# ADDENDUM NO. 3

**January 18, 2024**

# CHESTERTON HIGH SCHOOL STADIUM IMPROVEMENTS Chesterton, IN 46304

**Addendum Three (AD.03)** to the drawings and specifications prepared by Gibraltar Design for **Duneland Chesterton HS Stadium Improvements** for Duneland School Corporation, Chesterton, Indiana.

#### 1. Sheet C-1.1

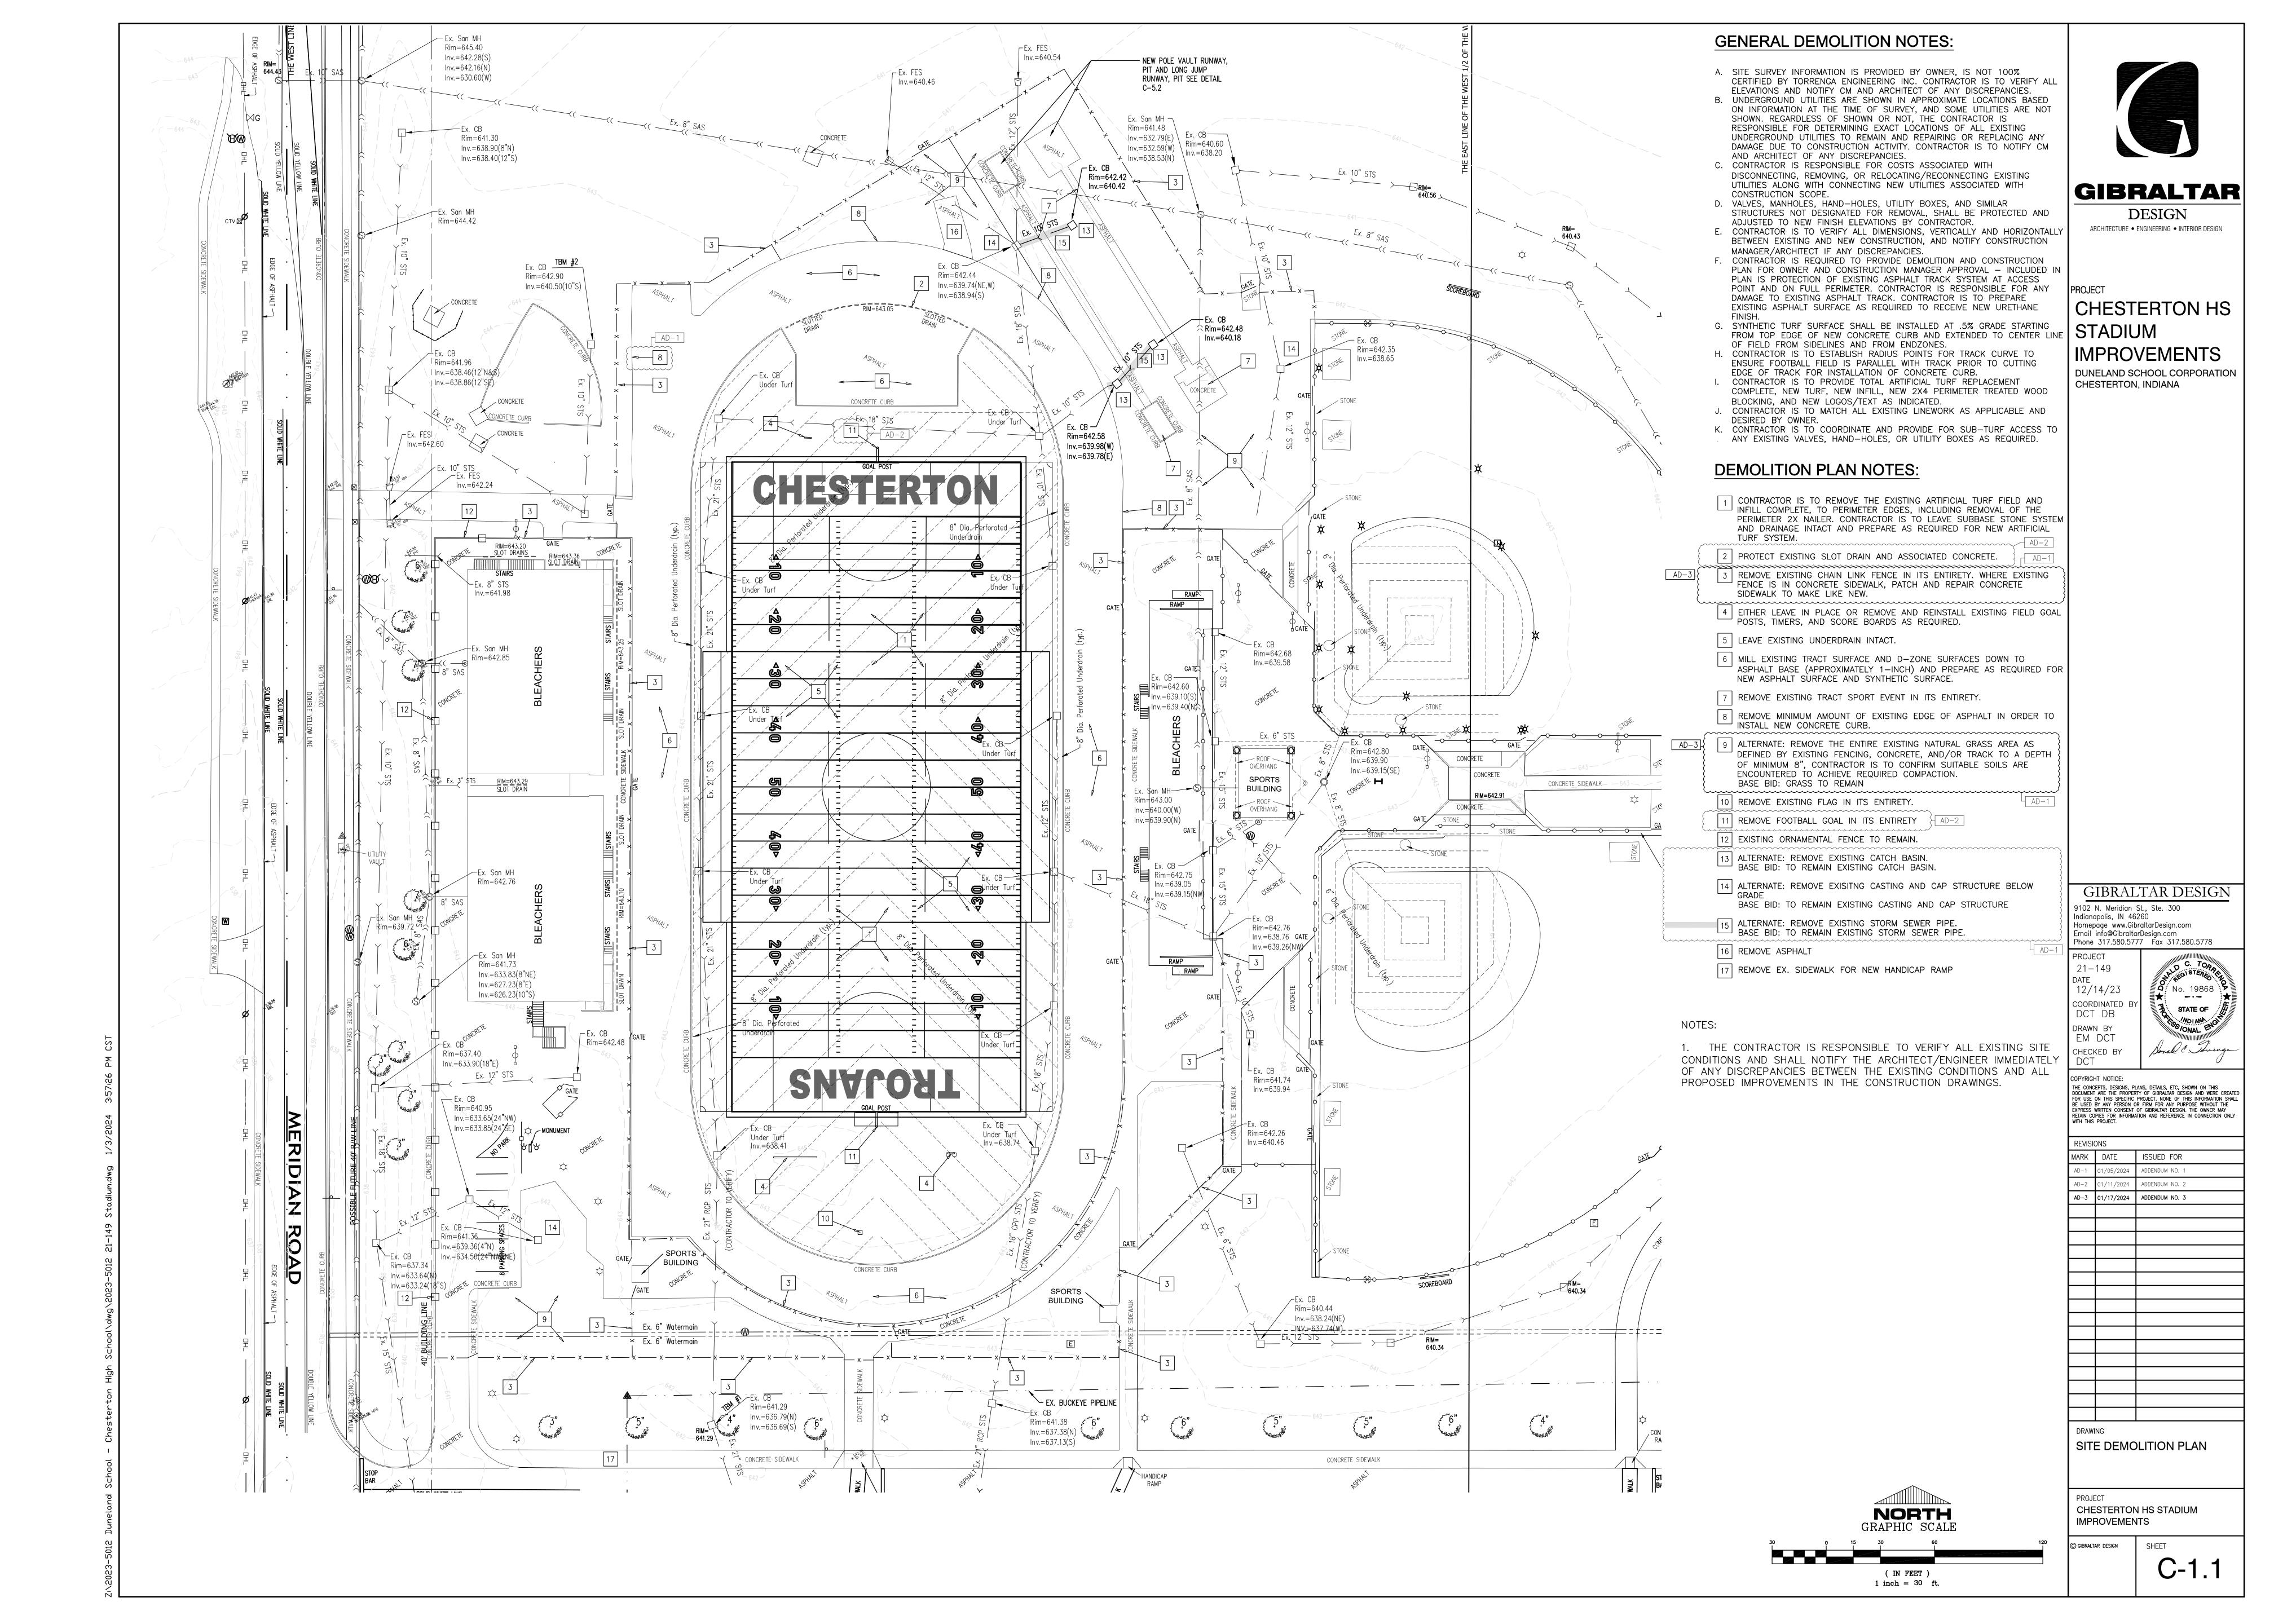
- A. Refer to revised full size drawing included in this Addendum for the following revisions.
  - 1. Demolition notes 3 and 9 are revised.

#### 2. Sheet C-2.1

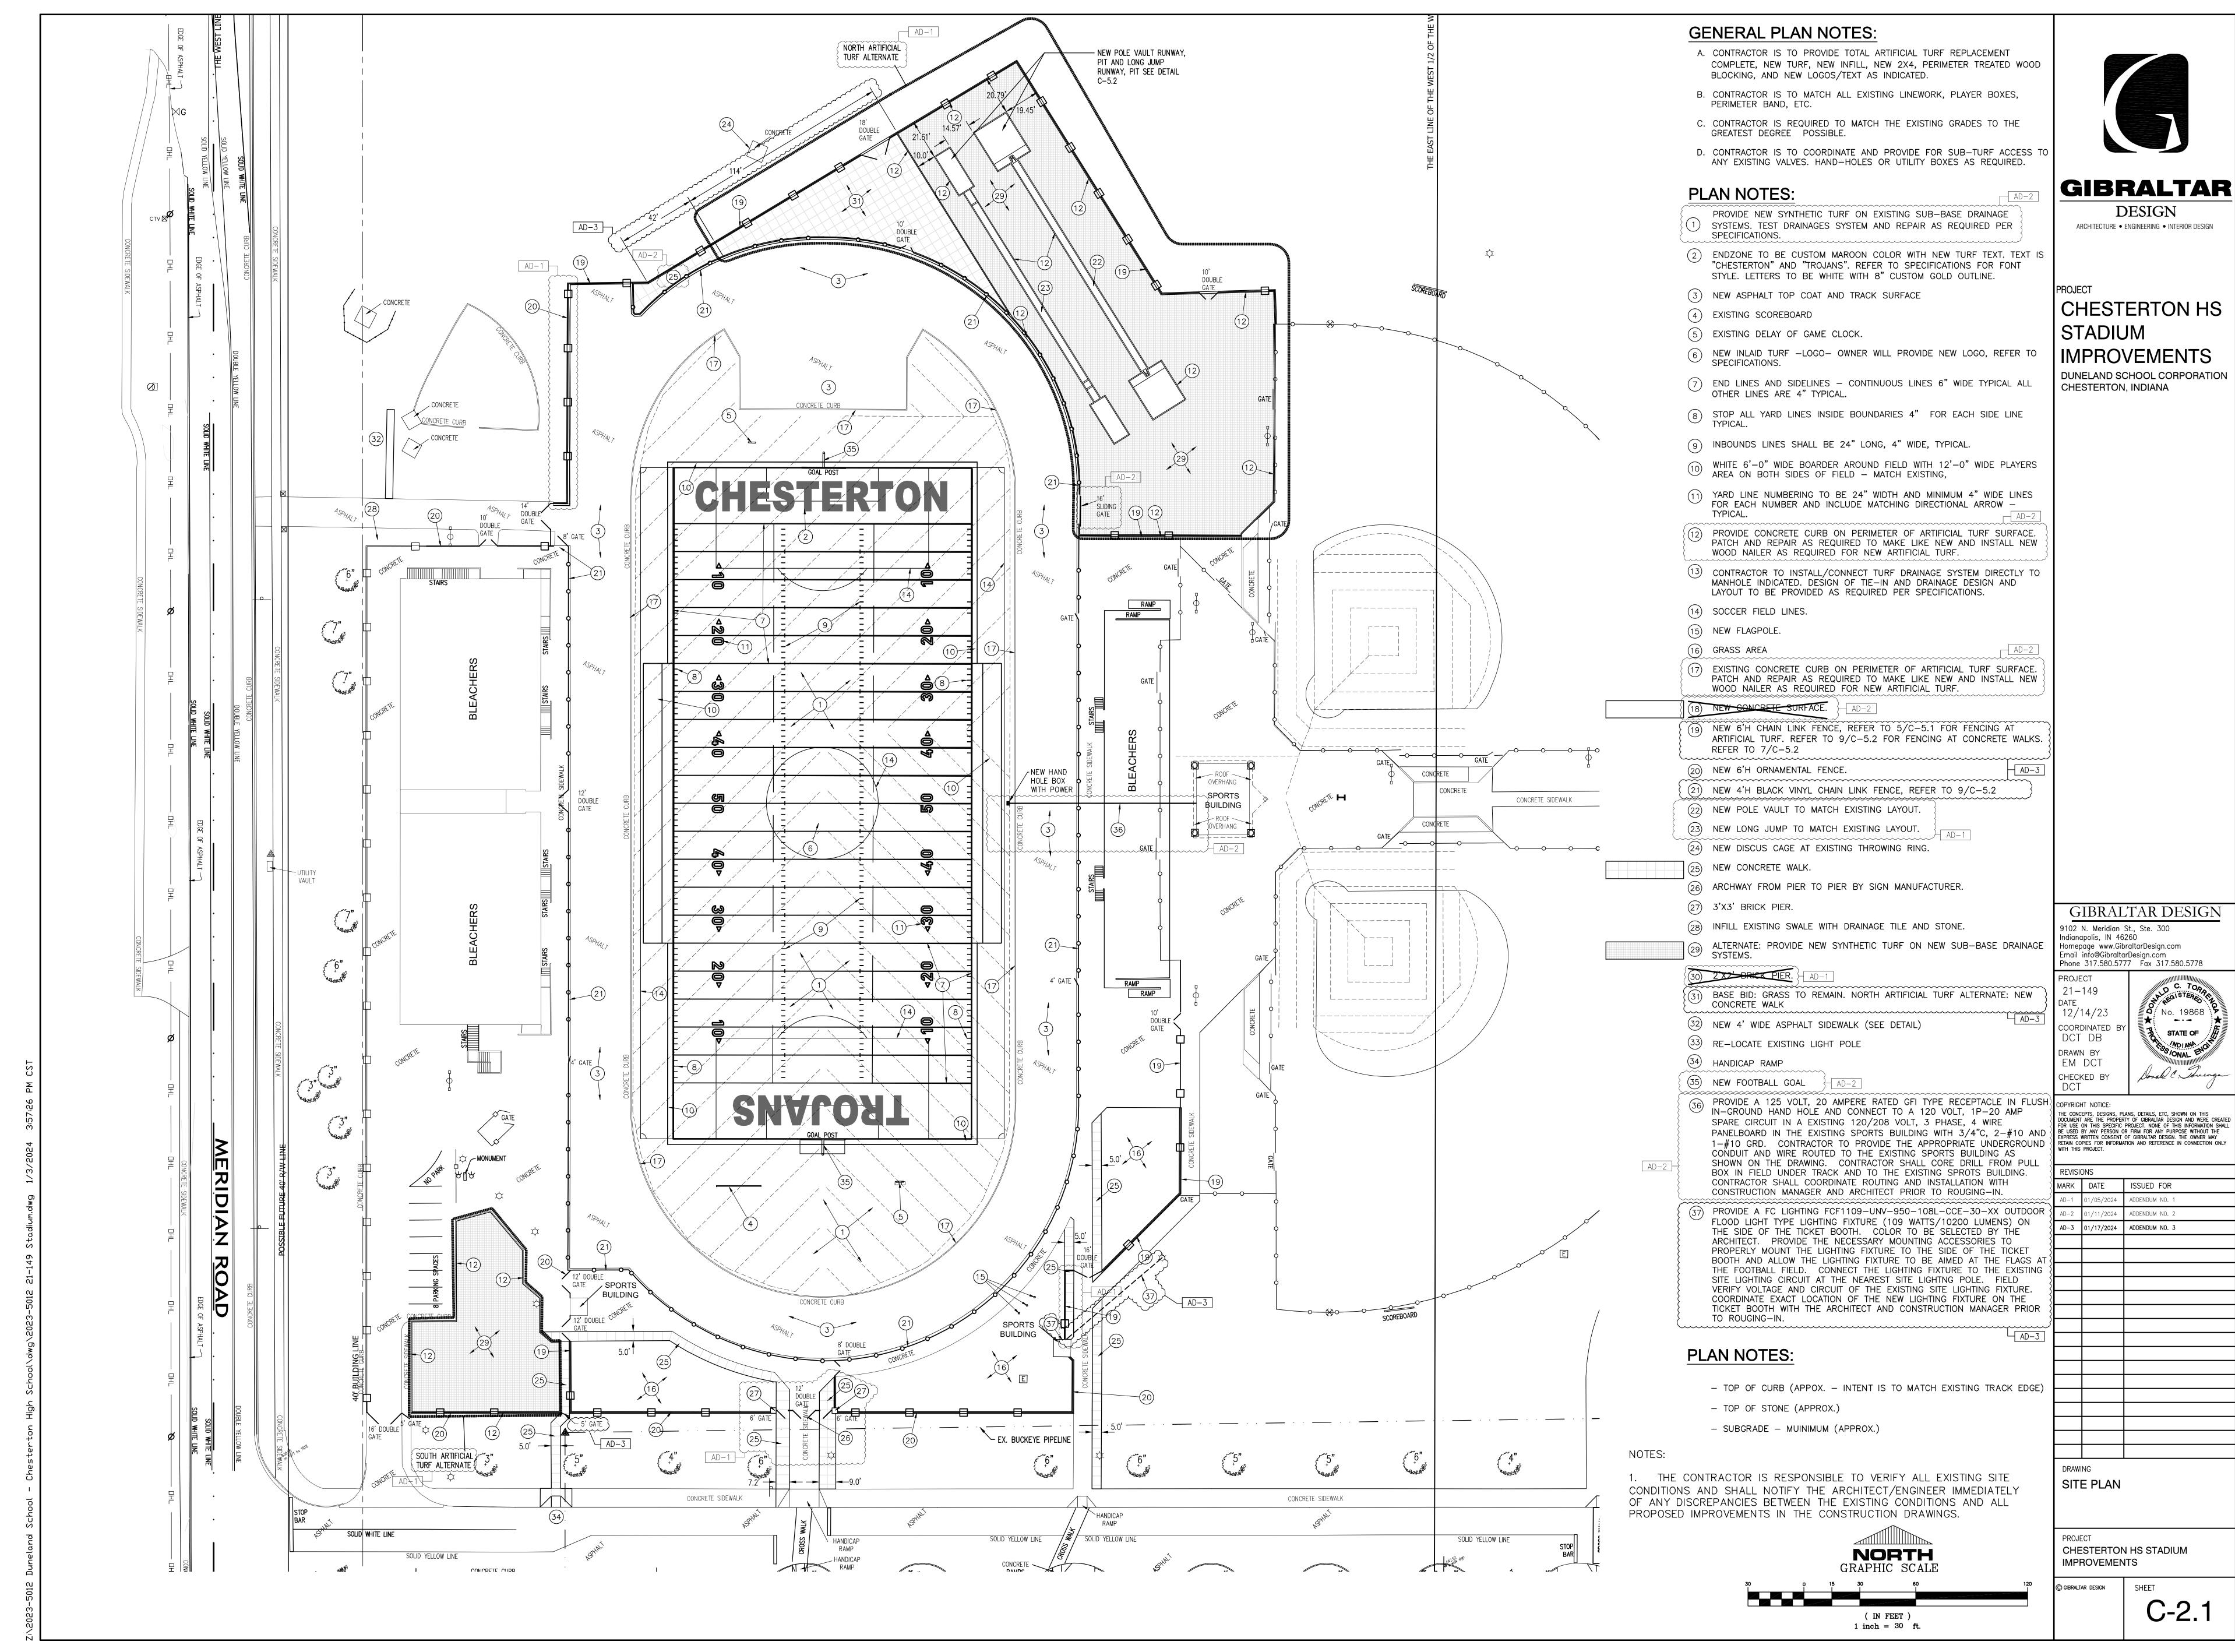
- A. Refer to revised full size drawing included in this Addendum for the following revisions.
  - 1. Ornamental 5' gate added at the southwest area.
  - 2. Ornamental 5' gate added at the Southwest area.
  - 3. Clarification of Plan Notes are revised, items 19, 21 and 31
  - 4. Key dimensions of concrete walk, items 25 & 31, on the North side are added. See plan note 31 also.
  - 5. Note 3s are removed at the North end of the turf area (not clouded in the drawing).

#### 3. Sheet C-3.1

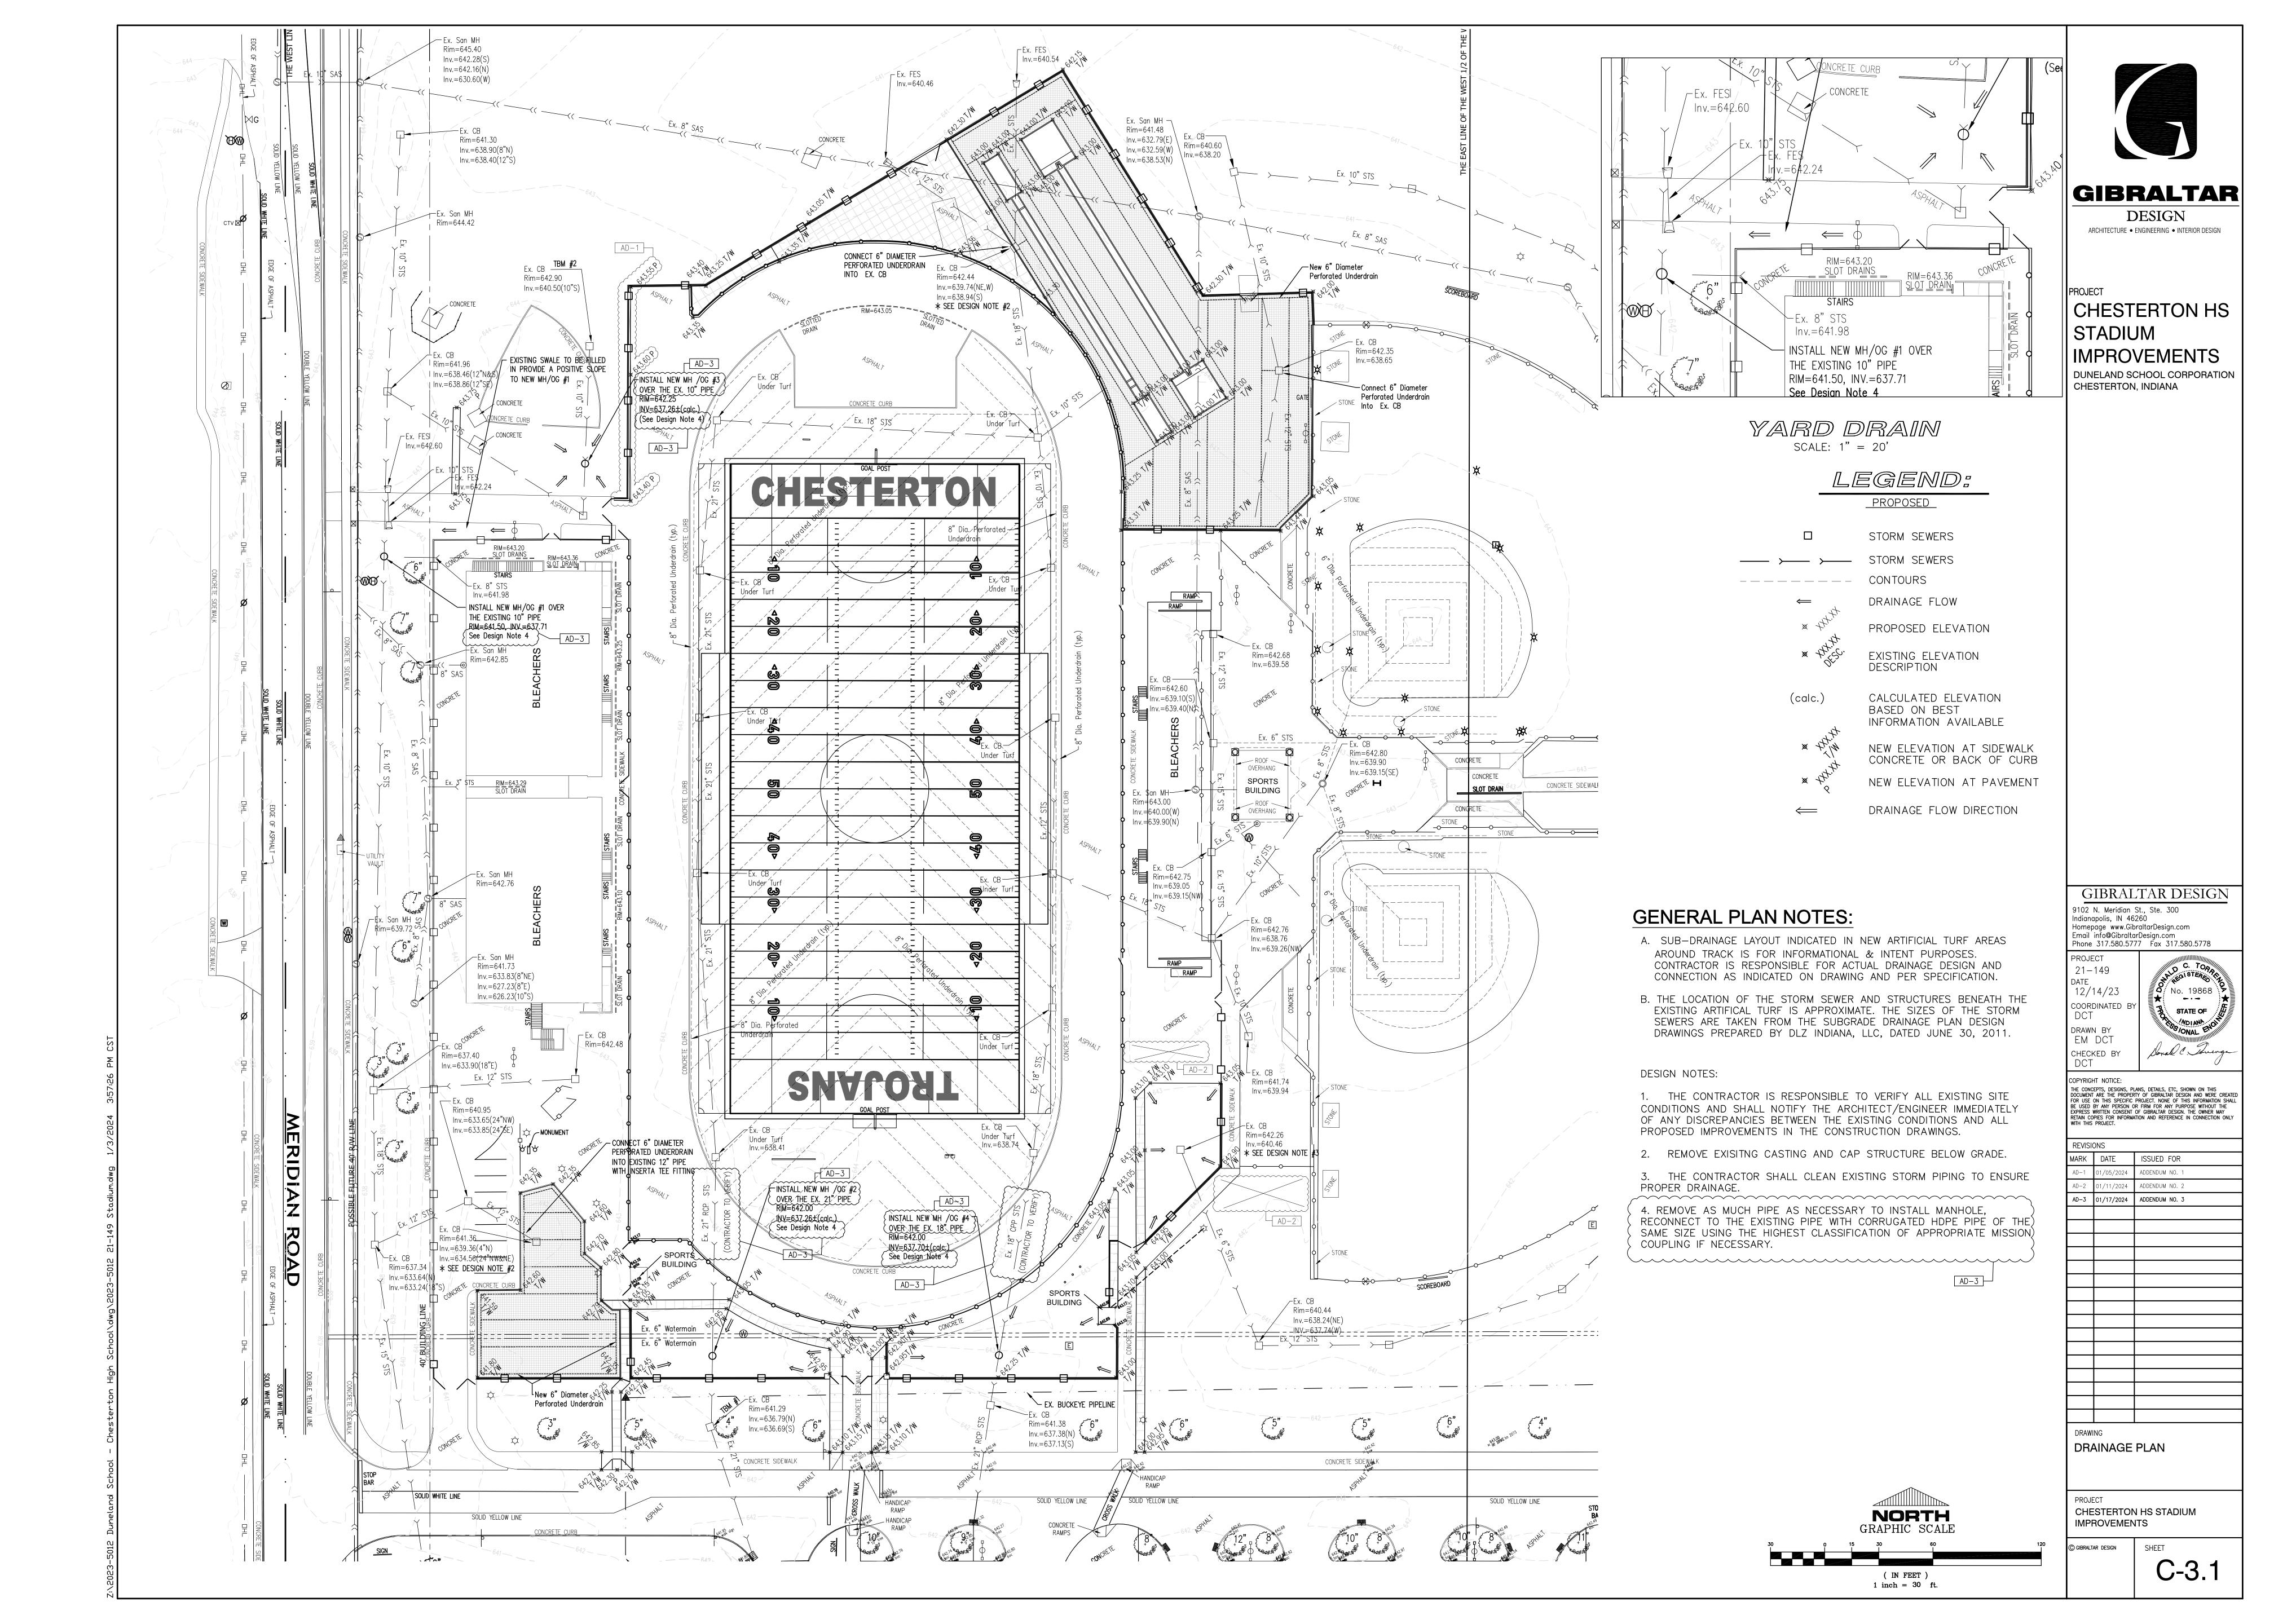
- A. Refer to revised full size drawing included in this Addendum for the following revisions.
  - 1. 3 CB's are replaced with MH /OG
  - 2. Design note 4 is added for new MH /OG #1, #2, #3, and #4
